To: Safe Roads / NZ Transport Agency
Attn: Liv Theunissen
Date: 21 August 2018
Re: ATP installation issues near SH6 Kingston / SH83 Otematata

Quality Assurance Statement	
<i>This document has been prepared for the benefit of New Zealand Transport Agency and Safe Roads Alliance. No liability is accepted by ViaStrada Ltd, or any of its employees or sub-consultants with respect to its use by any other person.</i>	Prepared by: Glen Koorey
	Reviewed by: Axel Wilke
	Project Number: 1090-14
	Project Name: ATP markings cycling review
	Version: 1

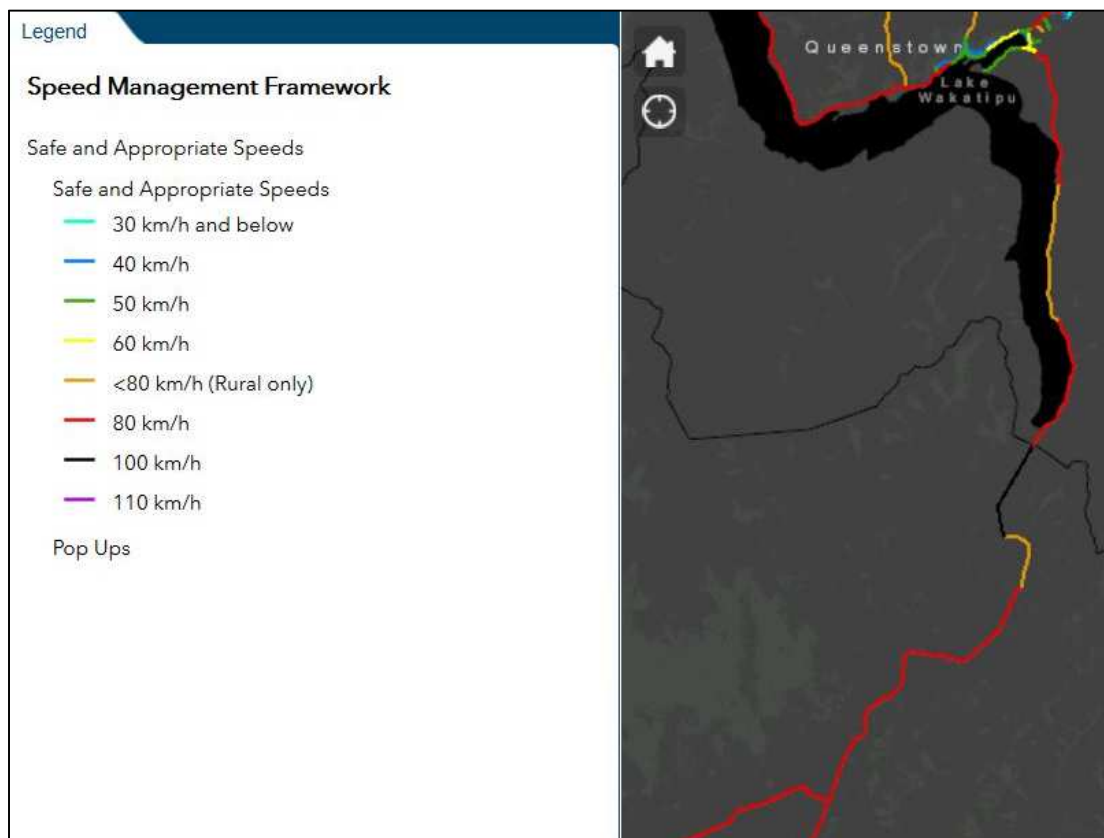
Although no photos are available post-installation, given the available shoulder width presumably the ATP has been placed just outside the edgeline, to encourage riders to ride inside it. The original desktop review only specified a few gaps in the ATP installation, mostly where there was shoulder widening or narrowing at side roads, curves and bridge approaches, as well as specific geometric restrictions at RP 85/7.51-7.23 and 85/6.85-6.65. On further review, it may also be appropriate to remove ATP on some partly obscured left-hand bends (see photo below), and to extend the excluded sections around the Otematata saddle.

- a) **Remove ATP** from narrow sections with limited sight distance; suggested sections are the partly obscured left-hand bends at RP 85/9.90-9.62 and RP 85/8.49-8.27 and around the

Otematata saddle between RP 85/7.60-6.85. Although this provides some shoulder space for cyclists to use, it is still somewhat narrow in parts with limited sight distance, minimising the improvement to cycle safety.

Recommended treatment: a) remove ATP at indicated locations
